CHANGE REQUEST

⌘ **25.213** CR **040** ⌘ ev **1** ⌘ Current version: **3.5.0** ⌘

Title:	⌘	Clarification of DL channelization code alignment
Source:	⌘	Panasonic, QUALCOMM Europe
Work item code:	⌘	*Date:* ⌘ 18, May, 2001

3GPP TSG-RAN-WG1 Meeting #20   *R1-01-0566*
Busan, Korea, 21-25 May 2001

Figure 8: Spreading for all downlink physical channels except SCH

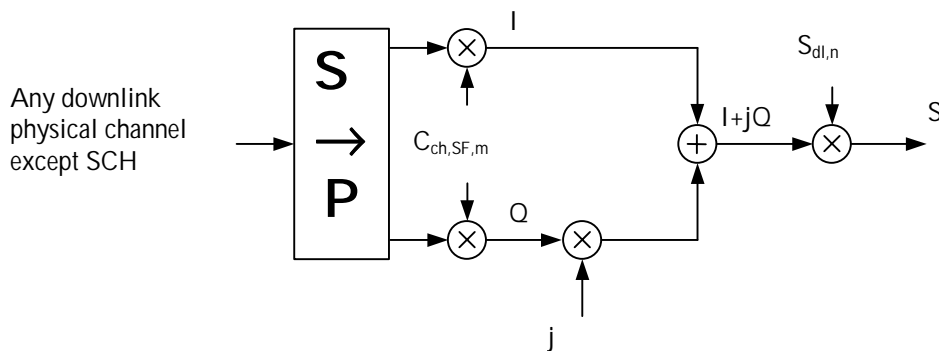
Reason for change:	⌘	The channelization code sequence is aligned to symbol boundary is not well described.
Summary of change:	⌘	To add following text: The channelization code sequence should be aligned in time with the symbol boundary.
Consequences if not approved:	⌘	Misunderstanding may happen to the channelization code phase.

Each pair of two consecutive symbols is first serial-to-parallel converted and mapped to an I and Q branch. The mapping is such that even and odd numbered symbols are mapped to the I and Q branch respectively. For all channels except AICH, symbol number zero is defined as the first symbol in each frame. For AICH, symbol number zero is defined as the first symbol in each access slot. The I and Q branches are then spread to the chip rate by the same real-valued channelization code $C_{ch,SF,m}$. The channelization code sequence shall be aligned in time with the symbol boundary. The sequences of real-valued chips on the I and Q branch are then treated as a single complex-valued sequence of chips. This sequence of chips is scrambled (complex chip-wise multiplication) by a complex-valued scrambling code $S_{dl,n}$. In case of P-CCPCH, the scrambling code is applied aligned with the P-CCPCH frame boundary, i.e. the first complex chip of the spread P-CCPCH frame is multiplied with chip number zero of the scrambling code. In case of other downlink channels, the scrambling code is applied aligned with the scrambling code applied to the P-CCPCH. In this case, the scrambling code is thus not necessarily applied aligned with the frame boundary of the physical channel to be scrambled.
